## **BCAC Structural WG Items**

### **October 2-3, 2018 Meeting**

**9-25-18 Notes:**

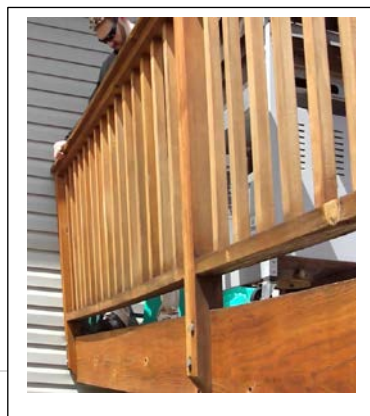
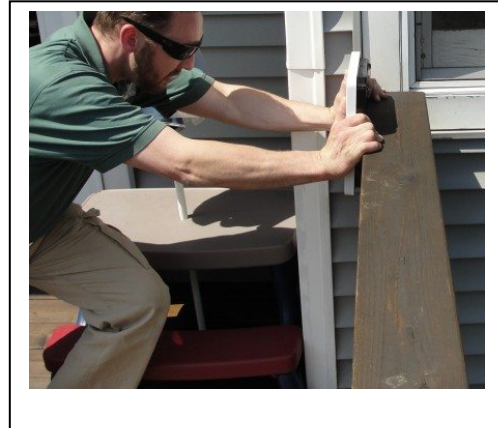
Recognizing that the IRC is based on historical performance, can you give an opinion on the pictured detail. According to the Loferski, Albright and Woeste paper, this guard system was capable of resisting 237# of outward load in the lab- no testing was done on downward load. This method has been used for years around the country and accepted as meeting the 200# code requirement by building officials. It is comprised of (2) ½" diameter thru bolts with washers into a 2x8 band board.

Notes 9-25-2018: Consideration of two proposals that will work together.

The proposal here is about direction of load applied, and applied to which element (top rail of guard or handrail). Study on guards showed that load application is an issue. How can this be built with normal construction? Gary is working with ASCE 7 on new deck loading criteria – early November maybe.
